Access Compliance Report Public Rights-of-Way (Pedestrian Signals)

Main Street: **DODGE_AVE** Cross Street: **NEWPORT_AVE** Location: **N**

ADA ID: **SGAT211018103351** Signal Type: **One Push Button-Non APS** Overall Compliance: **No** Severity Scores: **BTN 1: 25** **BTN 2: N/A** **No BTN: N/A**

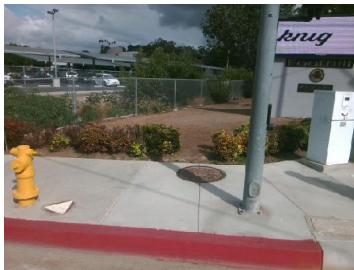
OC Std/PROW: **R404.2, R404.3**

Possible Solutions: Remove and Replace Clear Space.
